1.0 APPLICATION SUMMARY

Applicant: Lyvwell Carrollwood SS JV 1 LLC
FLU Category: Residential -12, Residential 4 and Office-Commercial 20.
Service Area: Urban
Site Acreage: 4.47
Community Plan Area: Greater Carrollwood Northdale
Overlay: None
Request: To increase square footage up to a 5% of the approved entitlements.

5.2 Recommendation

2.3 Proposed Site Plan – General Site Plan – (partial provided below for size and orientation purposes. See Section 8.2 for full site plan)

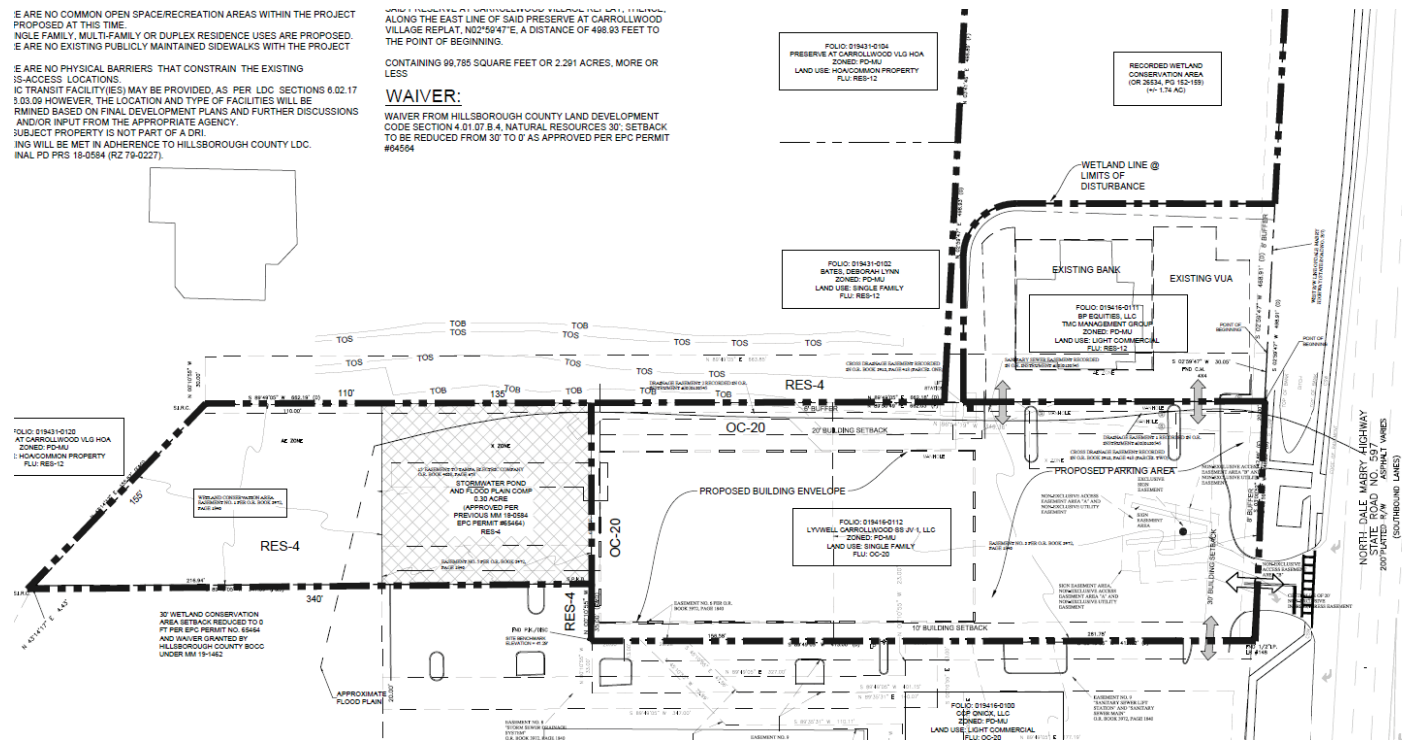
As shown in the table above, at the time of this modification the RES-4 portion of the site was calculated with consideration to the existing and proposed environmentally sensitive wetland. Despite the developer's efforts, the 0.30 acre wetland mitigation area has not established itself within the monitoring period per the EPC, and is deemed not successful. As such, the area has not yet met the criteria to be considered a wetland. EPC has stated that it is an out of compliance wetland mitigation area, and has requested that the developer instead purchase wetland mitigation bank credits from the Bullfrog Creek Mitigation Bank. A copy of the EPC agreement has been provided as part of this PRS.

As shown in the table above, the 0.30 acre portion within the RES-4 FLU area has been redistributed to show as uplands, increasing the allowable square footage by 5,717.25 SF. With this recalculation, the site is now permitted up to 104,952.38 SF based on the Hillsborough County Comprehensive Plan. The developer is committed to proposing a mixed-use development which will then be able to benefit from Policy 19.3 as approved today, stating the development is then entitled to an increase in the FAR by 0.25. The developer is seeking a minor modification which restricts the amendment to a 5% increase of square footage, thus the developer is not requesting the total allowable square footage (104,952.38), and instead is proposing a maximum building area of 103,639 SF.

8.2 Proposed Site Plan (Full)

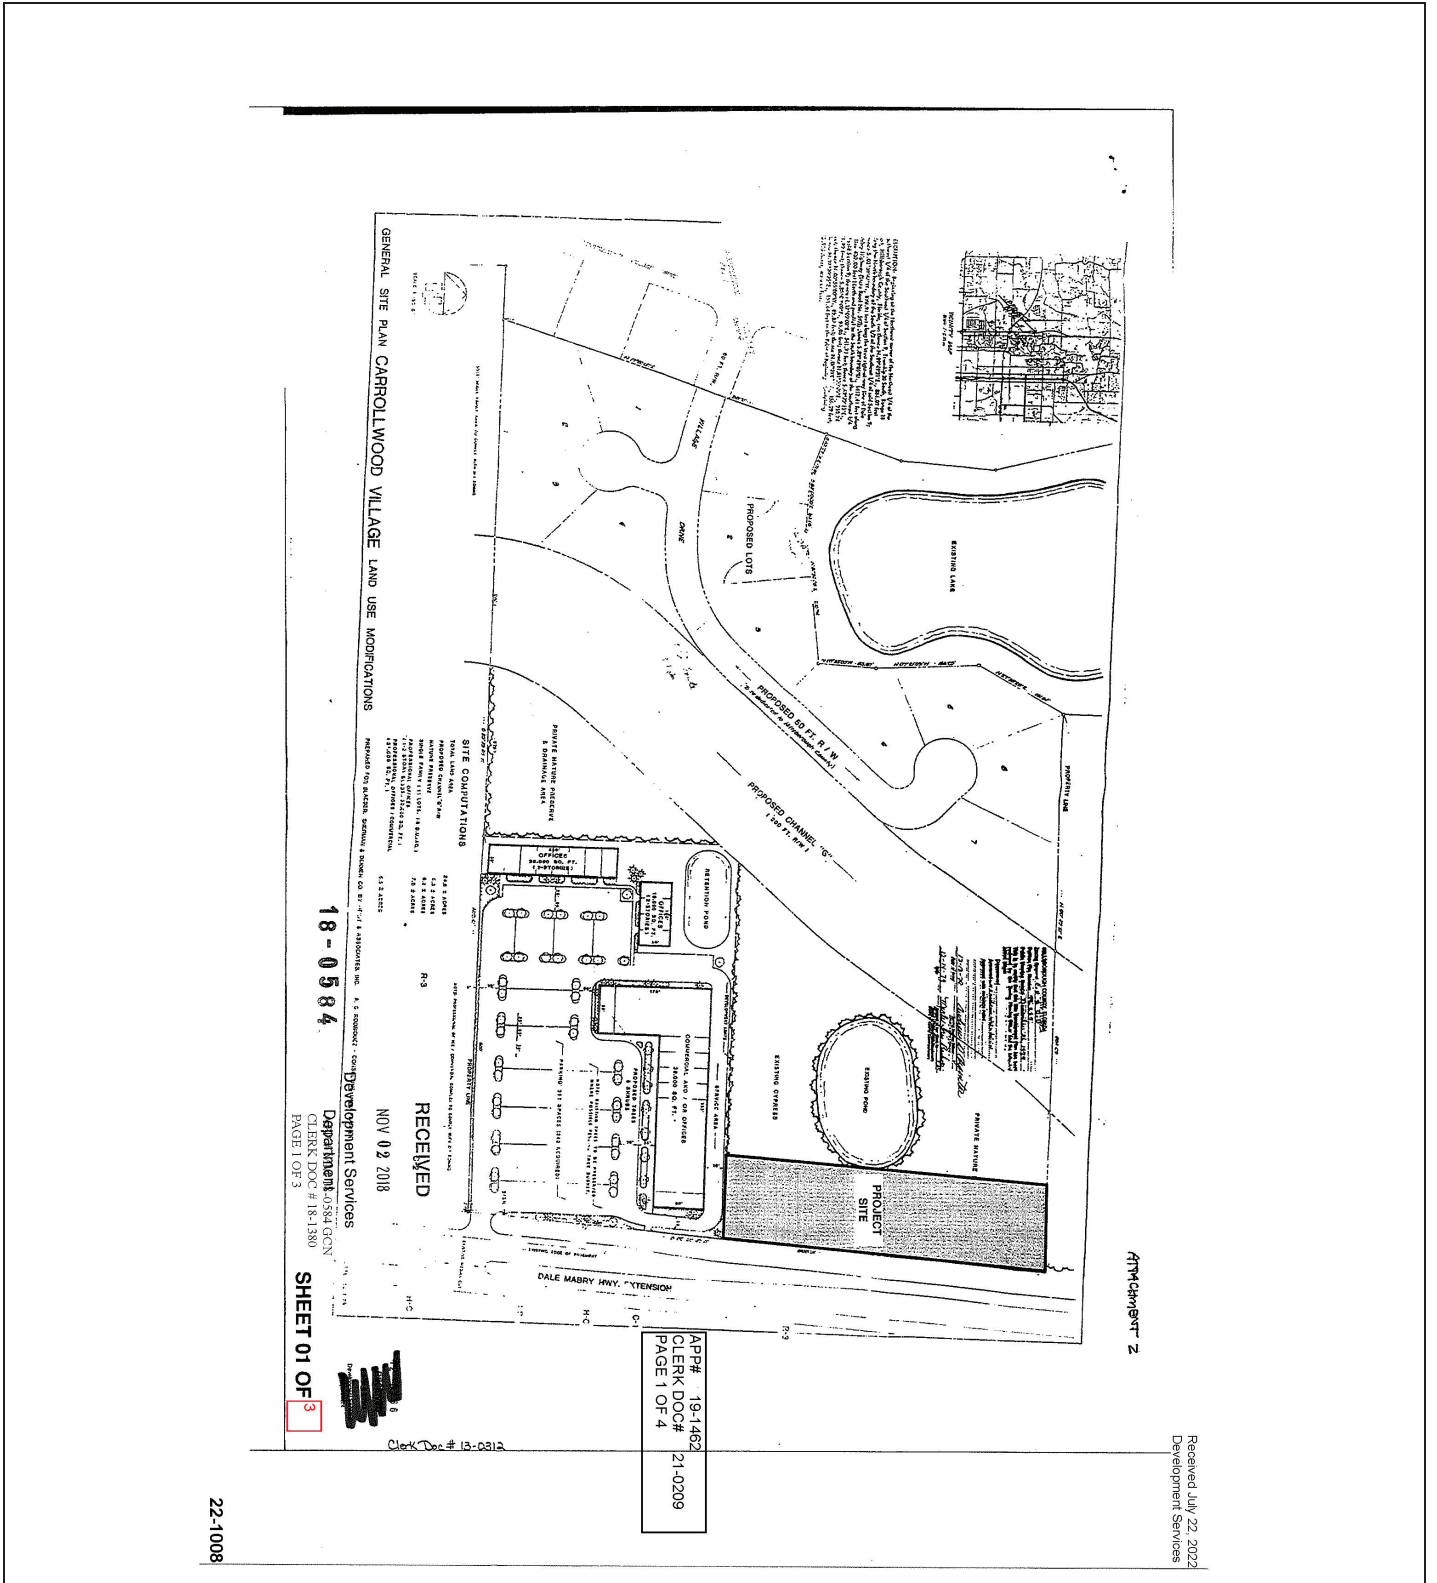
The Environmental Protection Commission, EPC, had requested a resubmittal of the proposed PRS Plans. In their comments, EPC indicated that *a wetland delineation by EPC staff determined that wetlands exist onsite. Wetland surveys*

have been reviewed by EPC and expire on 6/22/23. The submitted plans (on 7/22/22) DO NOT accurately depicted the approved wetland lines for the project area. The applicant needed to correctly label the wetlands on folio # 019416-0110. The wetland line must appear on all site plans, labeled as "EPC Wetland Line", and the wetland must be labeled as "Wetland Conservation Easement" pursuant to the Hillsborough County Land Development Code (LDC). The applicant updated the site plan and it was received by our Department on 9/7/22 and 9/22/22. EPC accepted the site plan changes and submitted their comments on 10/3/22. Planning Commission staff submitted a Memo finding this request inconsistent with the Comprehensive Plan due to the Environmental and Sustainability Section of the Plan on 9/23/22. The inconsistency finding by the Planning Commissions was due to the EPC objection of the Site Plans submitted on 7/22/22. Planning Commission staff could not update their memo after EPC updated their comments approving the project's Site Plan revisions, prior to the filing of this report.

The subject site is comprised of three different Future Land Use categories, Residential-12 (RES-12), Residential-4 (RES-4), and Office Commercial-20(OC-20). Planning Commission staff is in agreement with the amended square footage calculations as proposed by the applicant on the revised uplands of the site, however, at the time of drafting this memo, revised EPC comments have not been received by staff, which requested a redesign of the proposed development layout to avoid wetland impacts.

24. Prior to certification, the applicant shall revise the PD site plan data table proposed uses to state that drive thru facilities, supermarkets, banks, copy/print/express ship stores, carwashes, quick lube shops, pharmacies/drug stores, marijuana distribution centers, bars, microbrew pubs, liquor stores shall be prohibited; and restaurants and coffee shops shall be limited to a maximum of 1,000 square feet, within the 10% retail space.
